PLAN COMMISSION MEETING AGENDA

TUESDAY, February 25, 2014
AT 6:00 P.M.

PROJECT: Sign and Light Plan Review – Drexel Town Square

PROJECT: Site Plan Review – Four Points by Sheraton

CURRENT
FIGURE 4b. BUILD-TO-ZONE

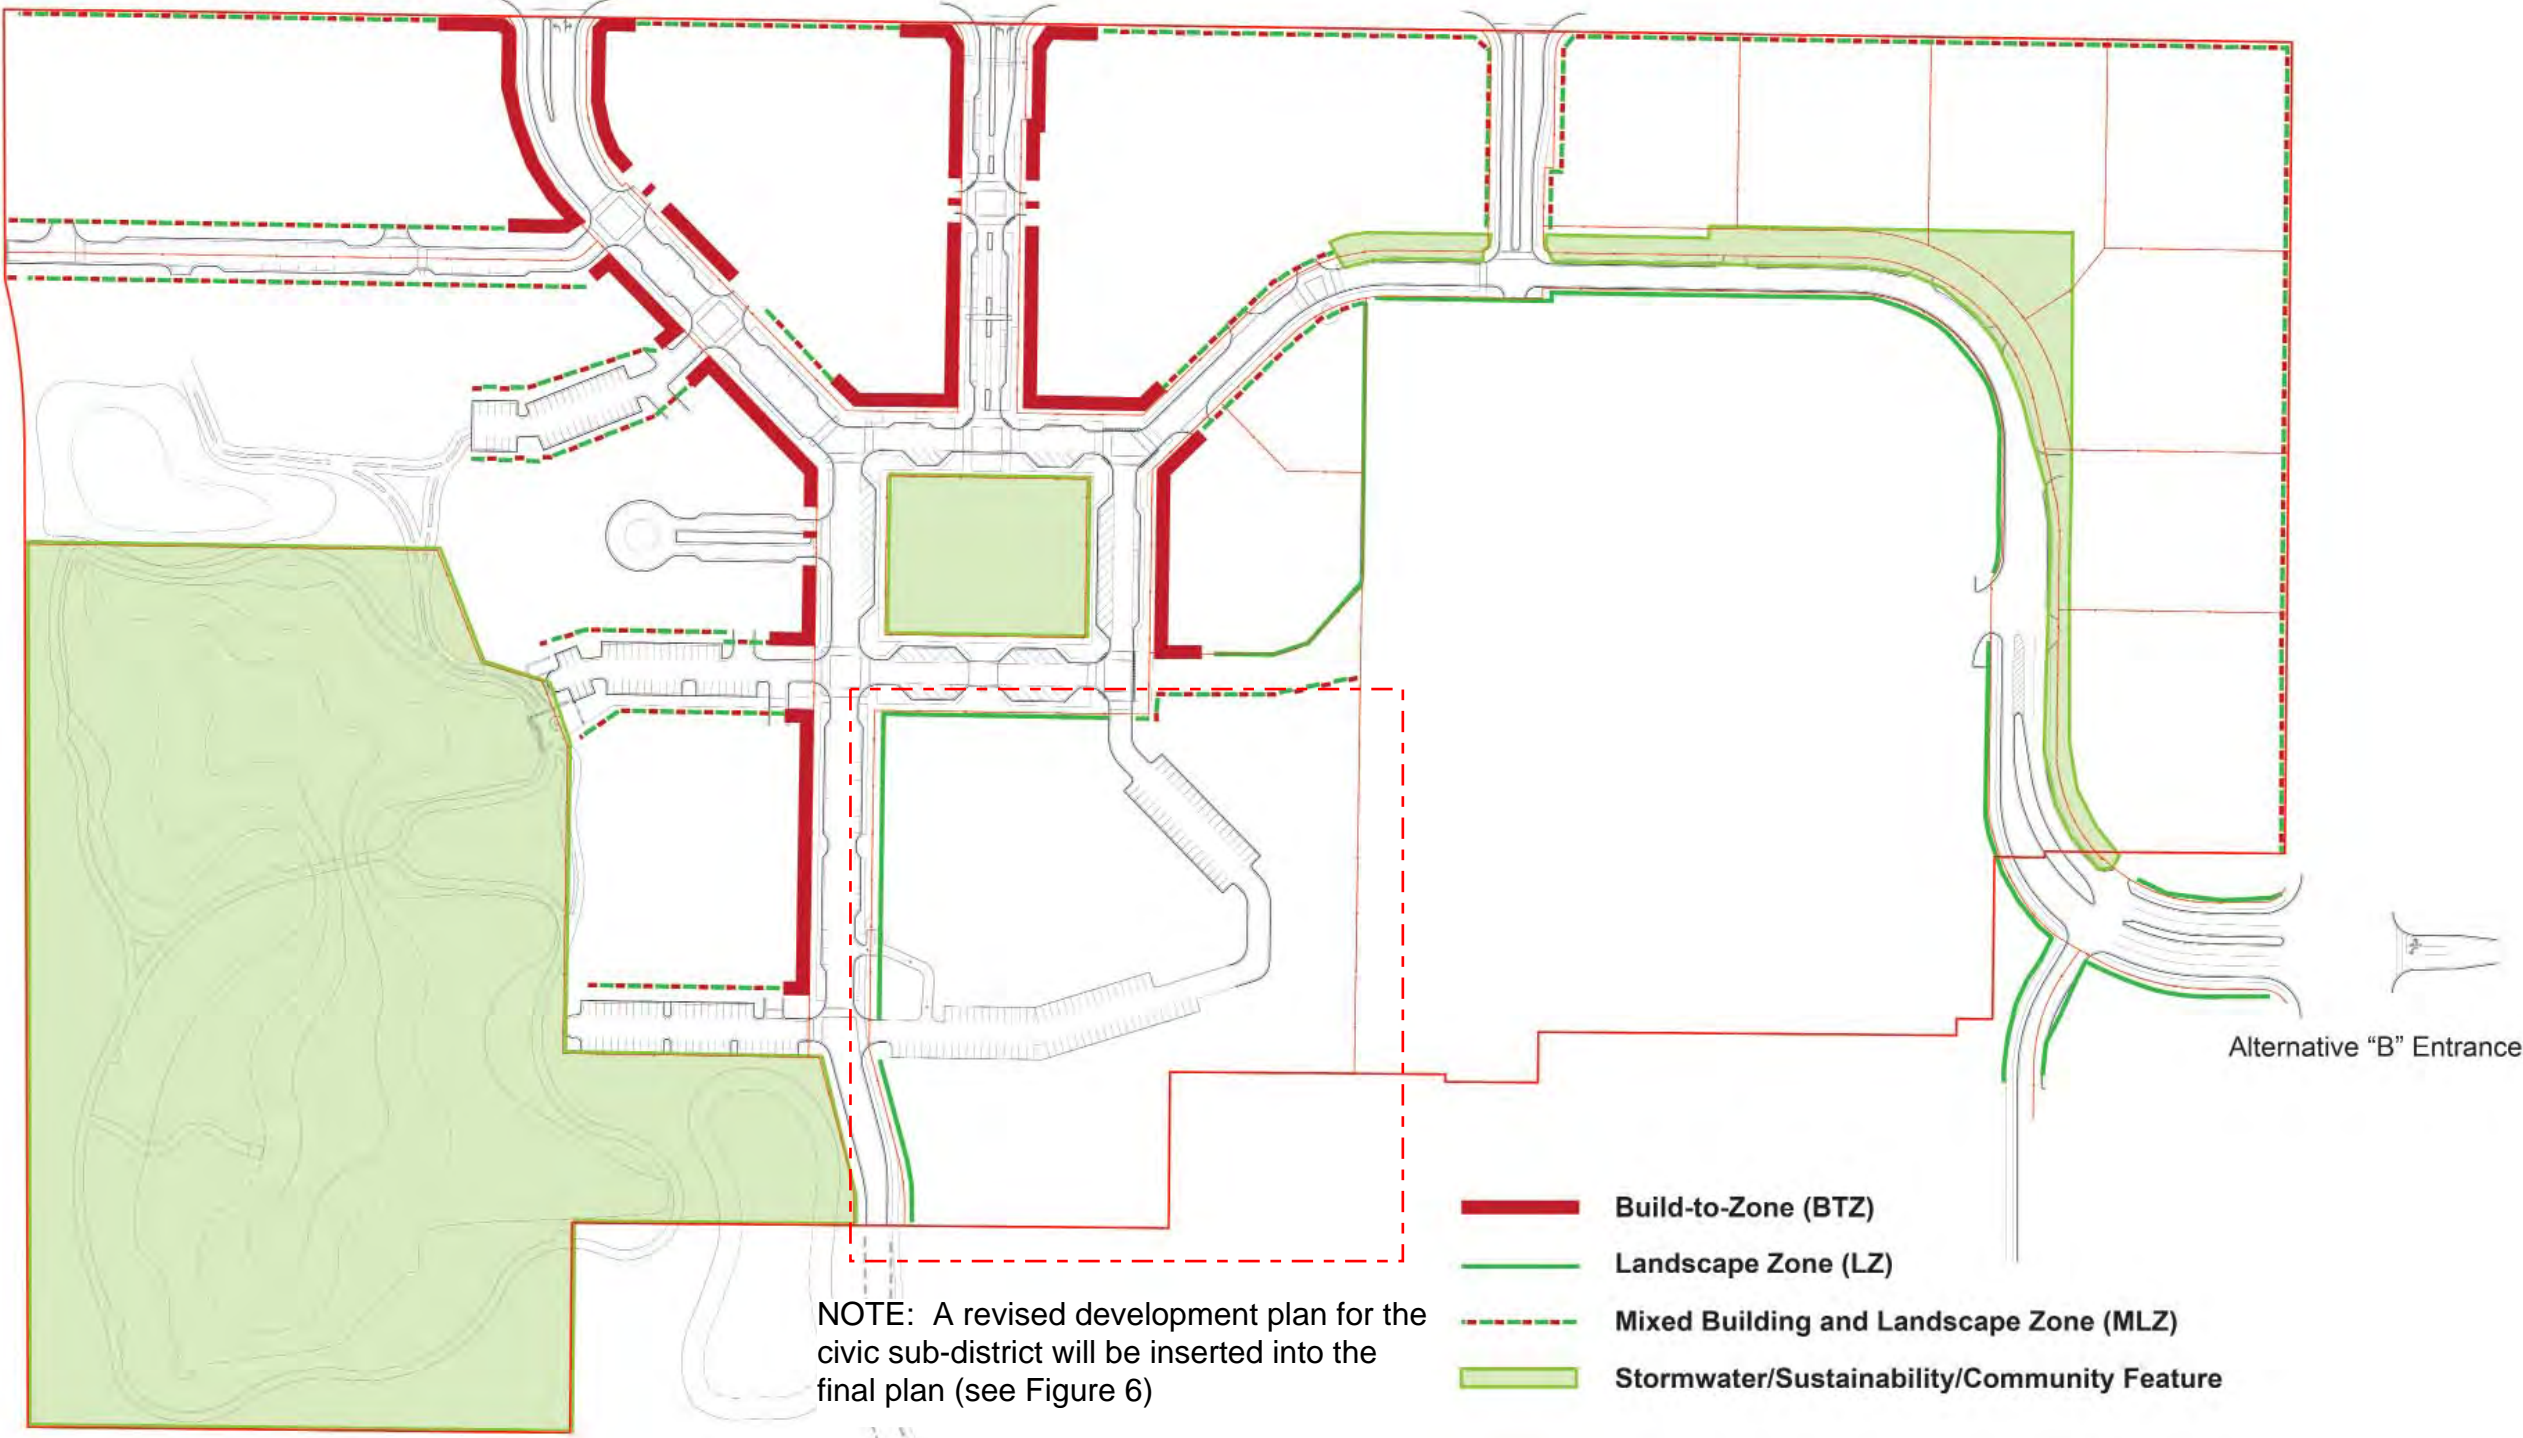
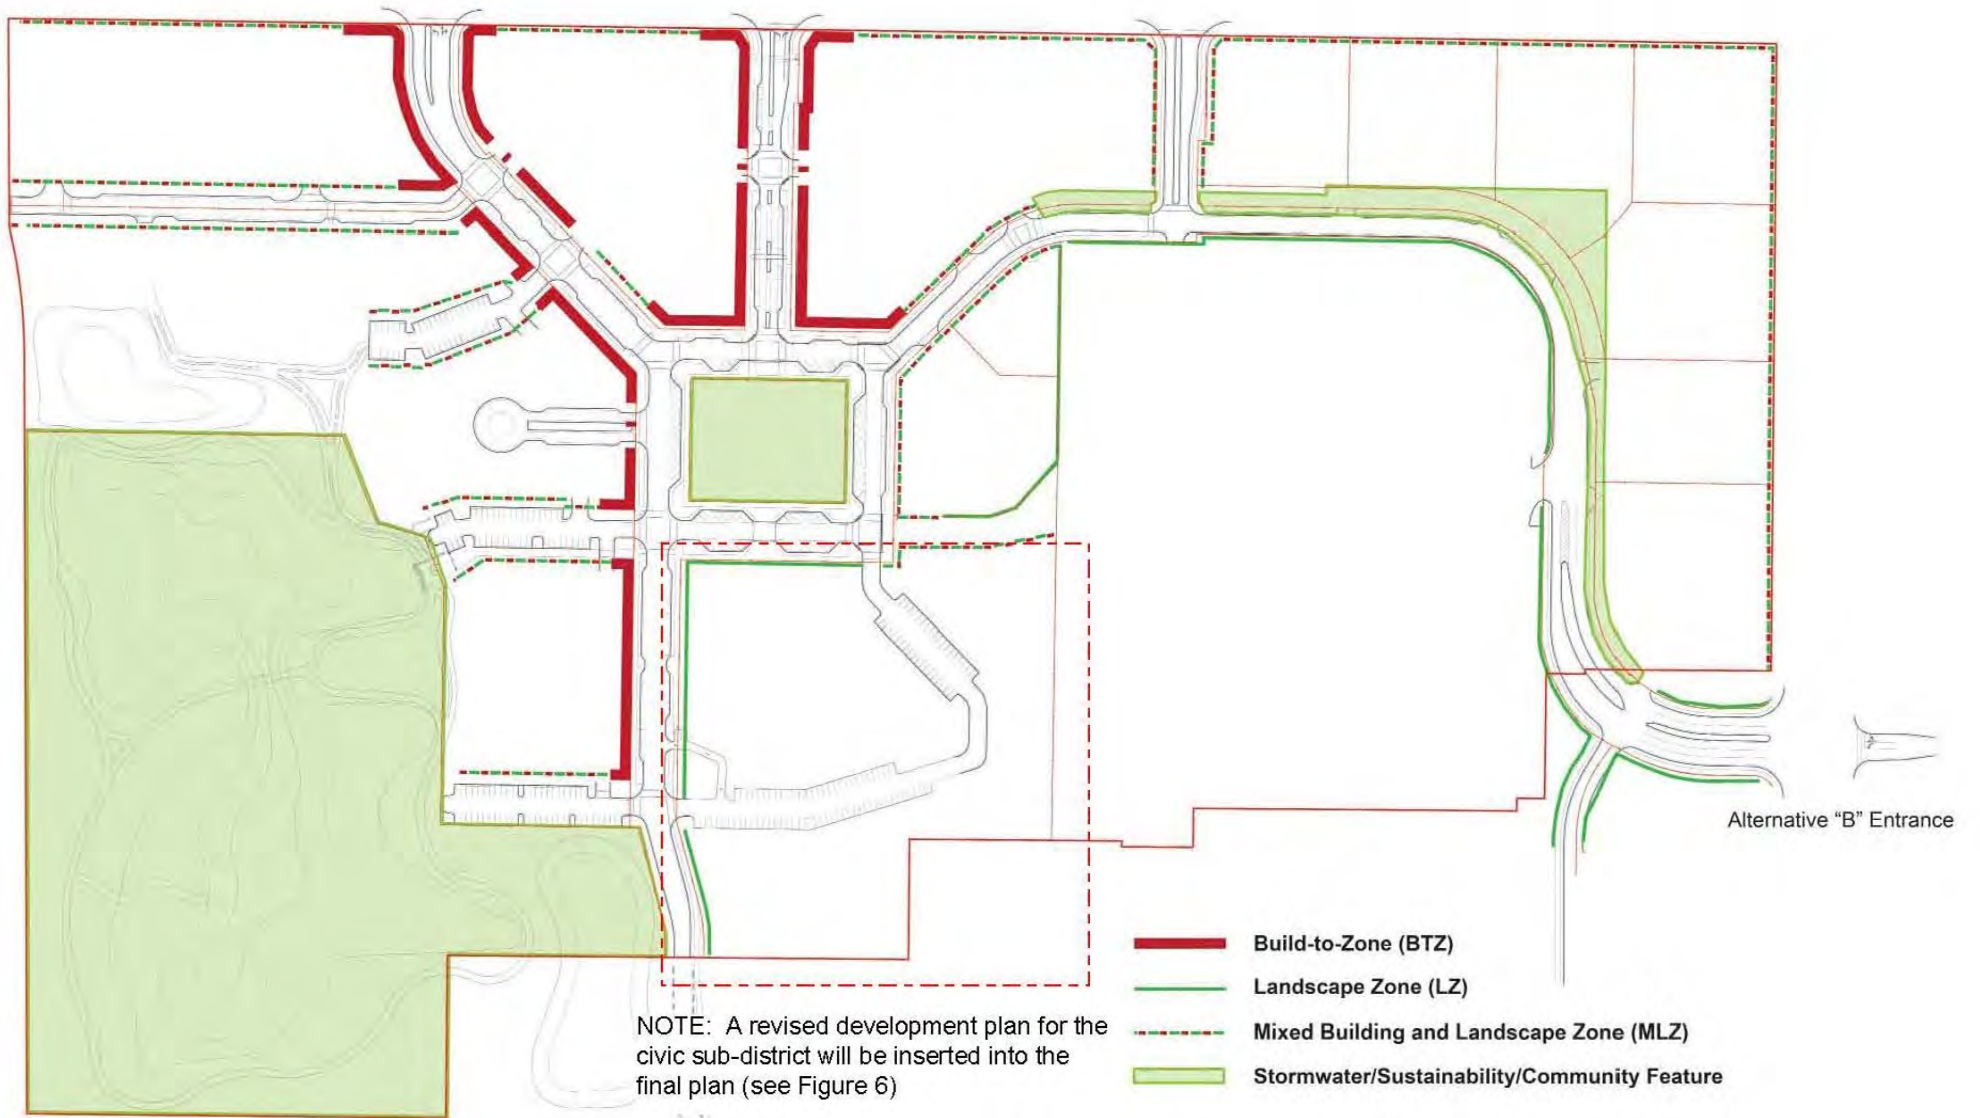
Commentary: One West Drexel, LLC, the City of Oak Creek, and Four Points by Sheraton are requesting approval of an amendment to the existing Drexel Town Square Mixed Use Planned Development District General Development Plan and Regulating Plan (“the Plan”). The proposed amendment involves the location of the build-to-zone in Figures 4a and 4b of the Plan.

The proposal is to replace the build-to zone (BTZ) along the east side of Market Street with a mixed building and landscaping zone (MLZ). A mixed building and landscaping zone is described in the Plan as an area “in which it is difficult to prescribe the precise locations of buildings on the lot...In such circumstances, the zone along the outer perimeter of the lot, abutting the public right-of-way, should be a combination of a build-to-zone and a landscape zone.” The change will allow flexibility in the development of the hotel property to be consistent with both the hotel’s design requirements and the goals of the DTSMUPDD. No other changes to the Plan are proposed.

STAFF RECOMMENDATION: That the Plan Commission recommends to the Common Council that Figures 4a and 4b in the Drexel Town Square Mixed Use Planned Development District General Development Plan and Regulating Plan be amended to replace the build-to-zone (BTZ) along the east side of Market Street with a mixed building and landscaping zone (MLZ), following a public hearing.

Sheet Title
EXTERIOR
ELEVATIONS

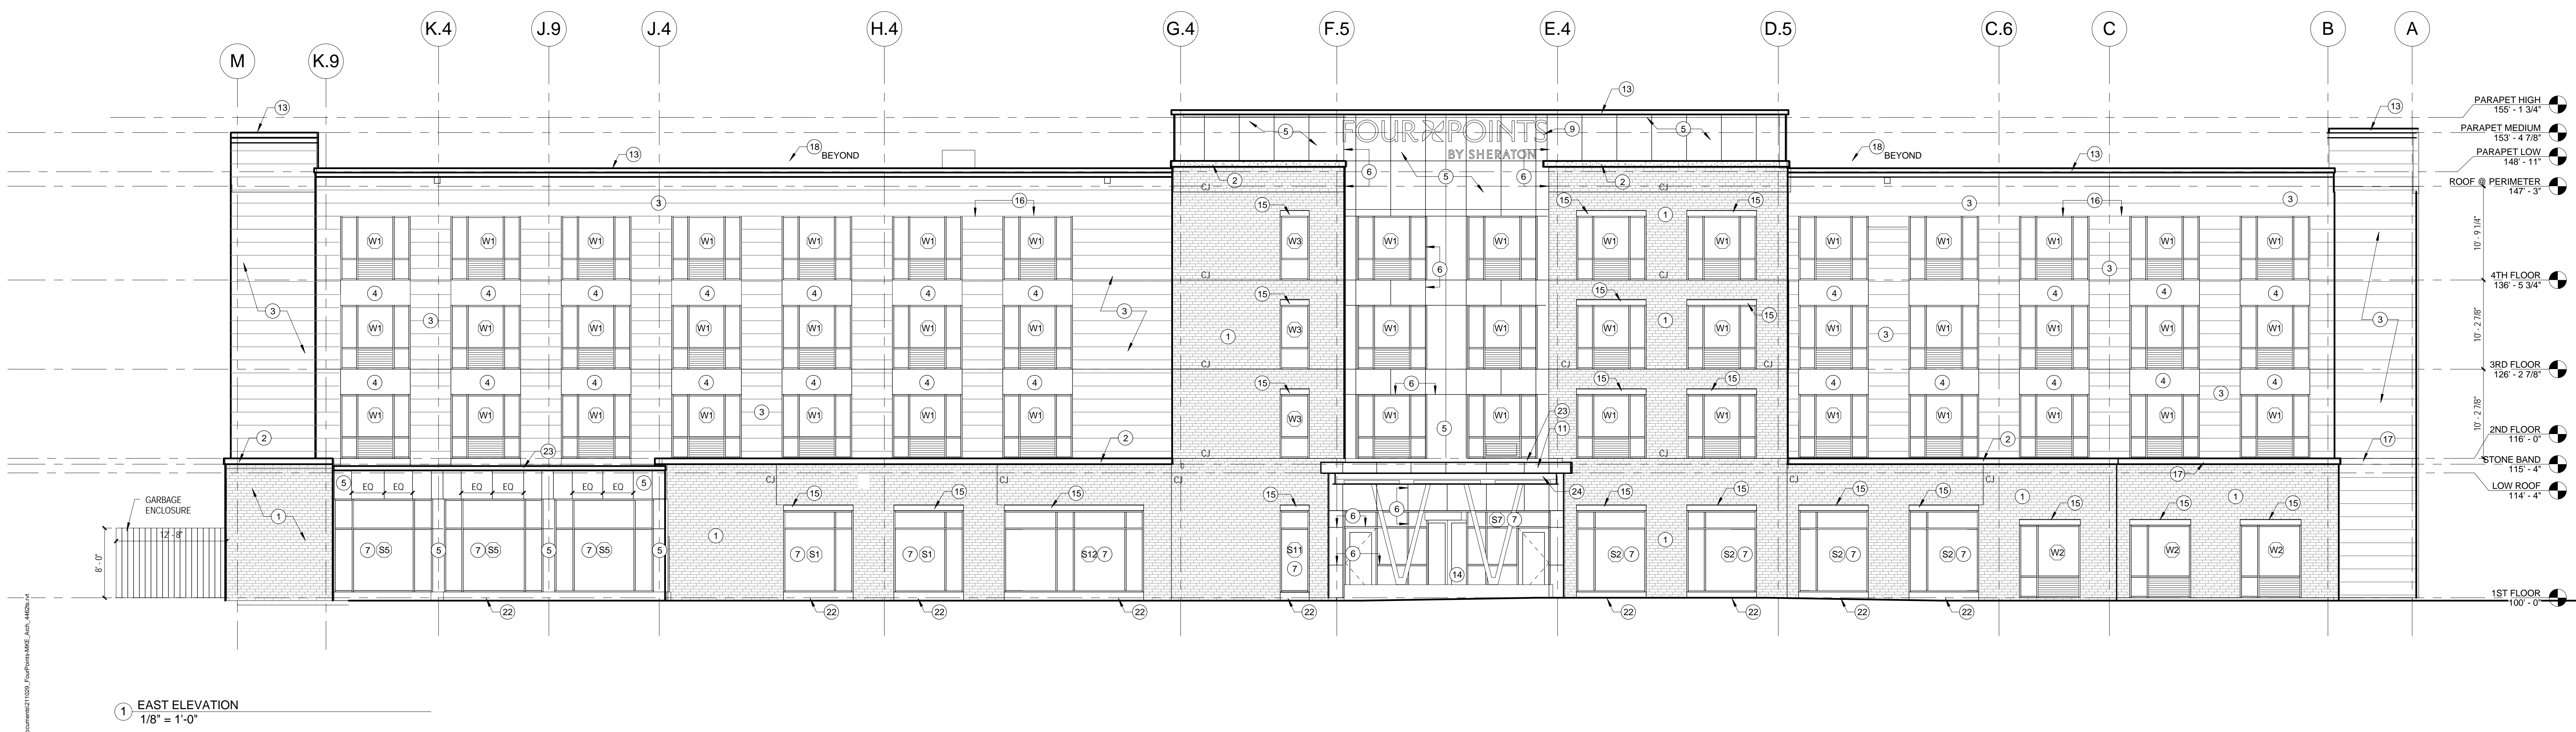
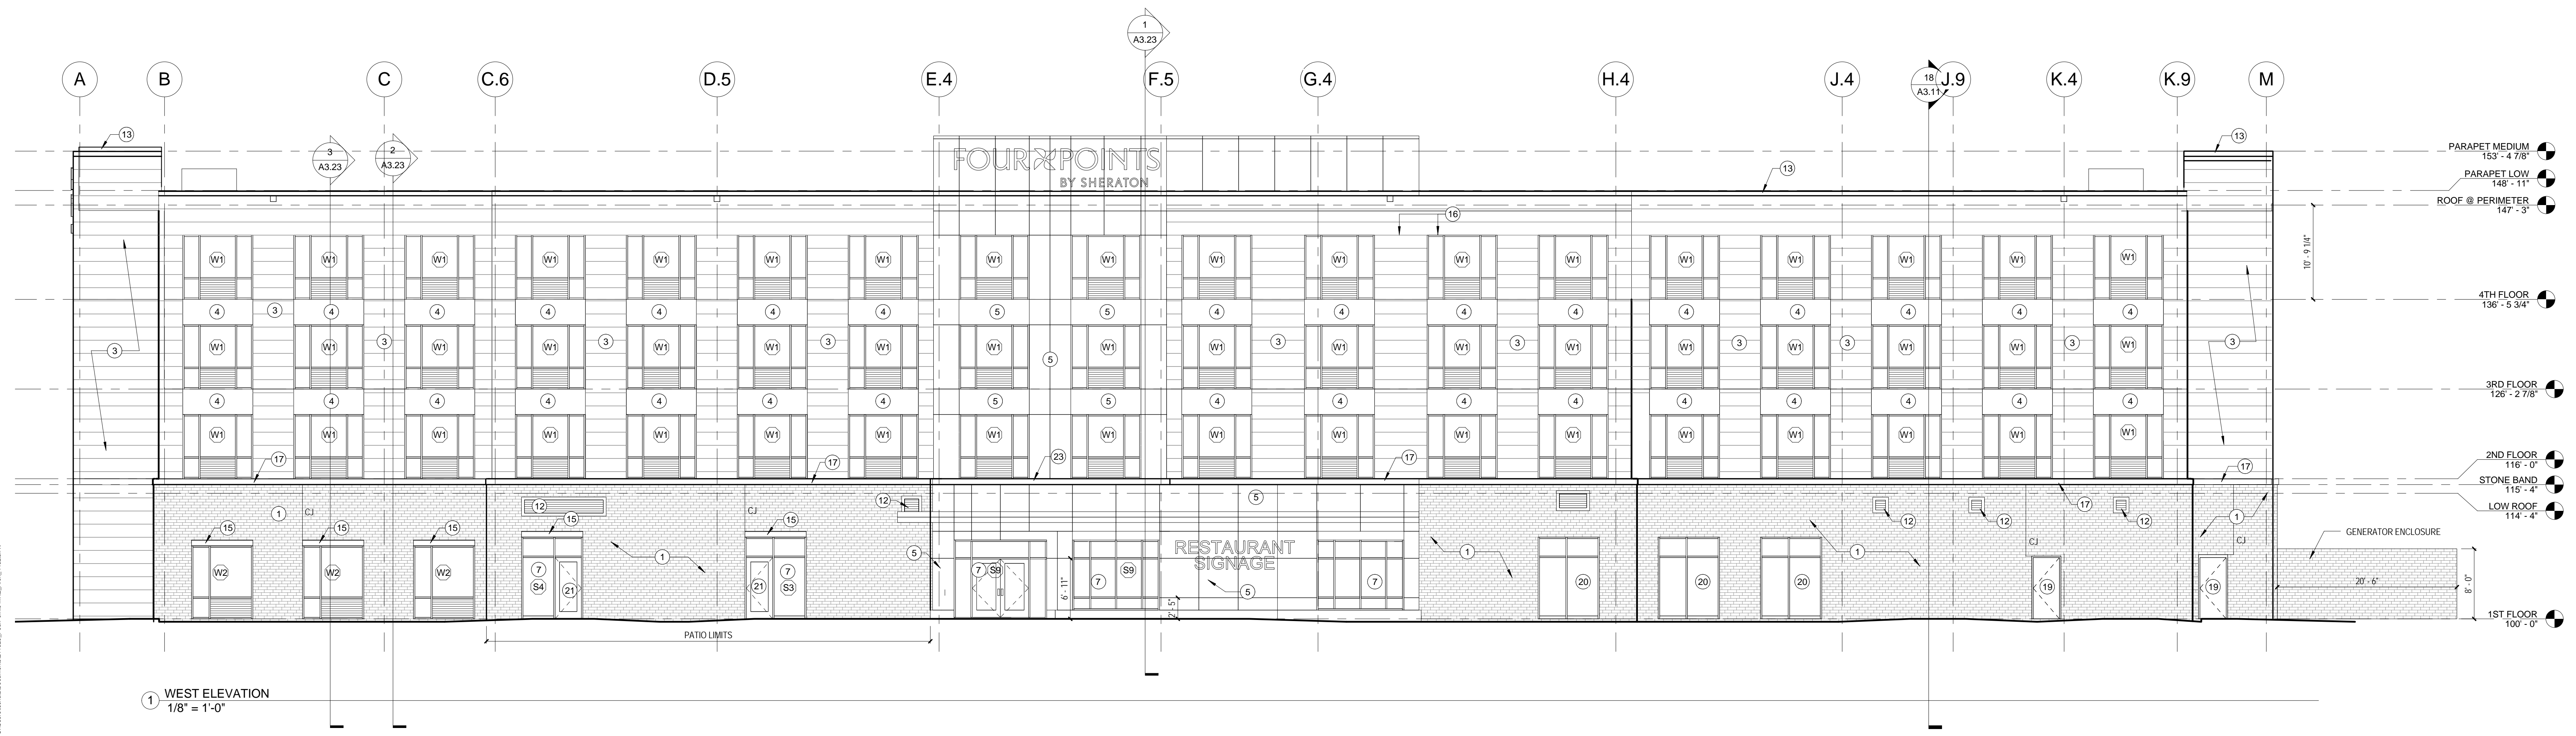
The color scheme for the exterior of the building is Autumn Haze Ironspot Colonial for the brick; graystone for the cast stone trim; grey for the fiber cement panels; and dark graphite for the composite metal panels, canopy, and window frames. Staff recommends mirroring the window treatments from the east elevation on the west, and embellishing the roof cornice to enhance the façade and to make it appear less “flat.” Window awnings lighting fixtures, hanging planters, seating area enhancements (umbrellas, canopy, trellis/ pergola, etc.), and other façade features are highly encouraged. Staff recommends mirroring the north tower windows and window treatments on the south tower and/or incorporating additional enhancements to break up the blank façade on that elevation.

Glazing requirements for hotels include a minimum of 25% of the glazing zone along the street frontage. Clear, non-tinted glazing should be maximized between 2 and 8 feet above grade. There is an option for substitutions to the street level window glazing requirement (up to 50%) in the DTSMUPDD Plan as mentioned above. Current plans indicate that the Market Street frontage glazing is at approximately 15.7%.

8. That the plans are revised to incorporate building façade recommendations and to meet the 25% residential glazing requirements.
